# Franklin Township

## Township Technical Review Committee (TRC)

### MEMORANDUM

Re: James R & Susan A. Morano – “C” Variance (ZBA-20-00016)  
730 South Middlebush Road (Block 37.03, Lot 44.01)

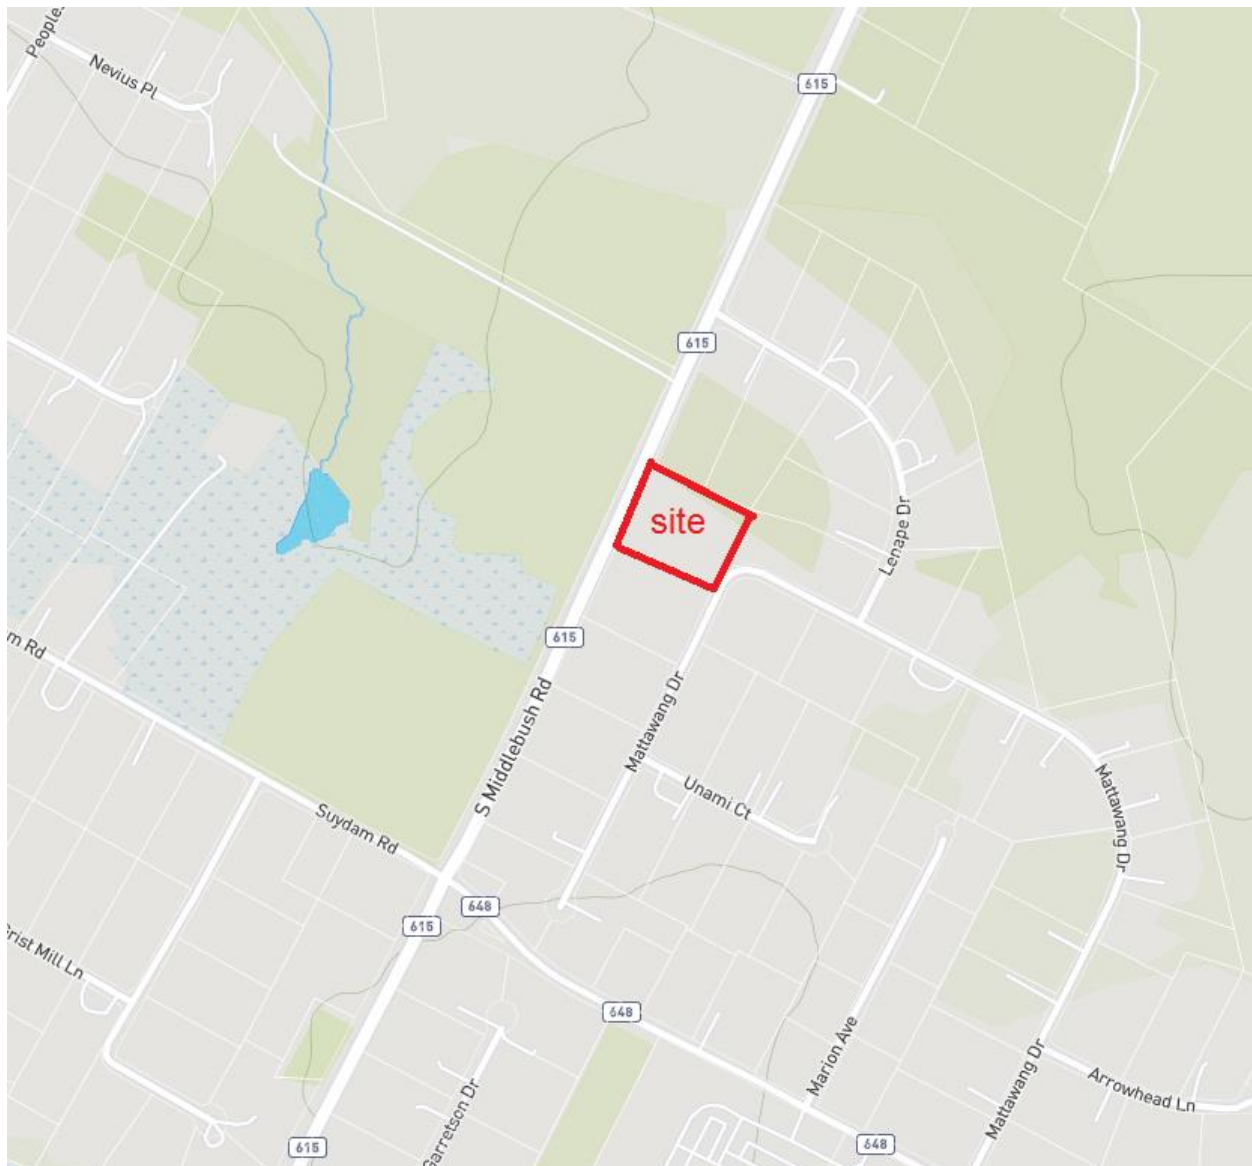
- a. The applicant will need to present testimony in support of the variance – i.e., hardship and/or benefits of granting the variance.

The applicant should demonstrate that the variance would not result in substantial detriment to the public good and will not substantially impair the intent and purpose of the zone plan and zoning ordinance. In particular, the applicant will need to ensure that the proposal would not substantially impact the character of the neighborhood. The following should be addressed: compatibility of the lot size, frontage and setbacks with that existing in the surrounding neighborhood.

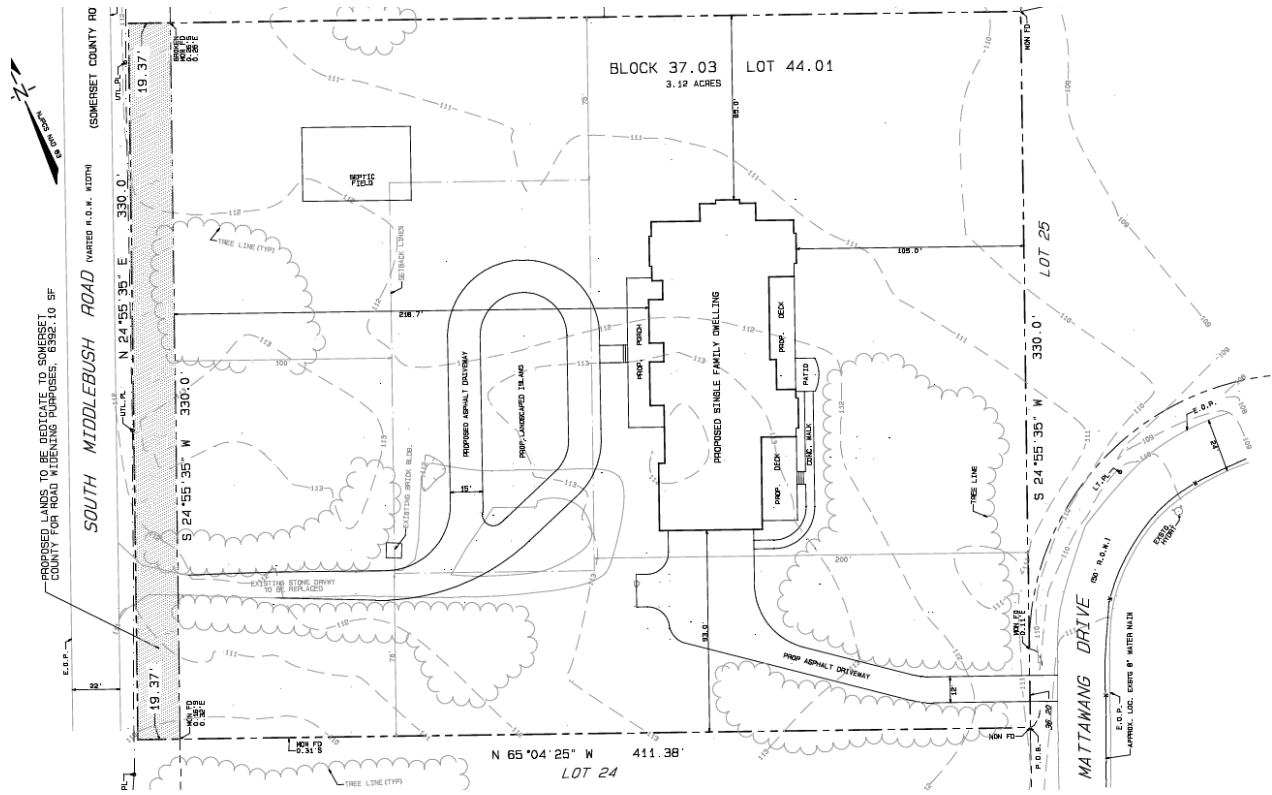
- b. Per the plan, the applicant proposes to remove the existing wooded area along the Mattawang Drive side of the site. It is noted that this is the portion of the site that requires the rear yard setback variance. Further, the *rear* of the proposed home would face the street (rather than the front of the house as is, obviously, typical). This would likely create a rather unorthodox appearance of the site from the ¼-mile stretch of Mattawang Drive that is in direct line with the rear of the property (aside from the lack of privacy for the applicant). It is *strongly recommended* that the applicant explore: preserving the existing wooded area along Mattawang Drive (or as much as possible) and/or supplementing this area with additional means of screening.
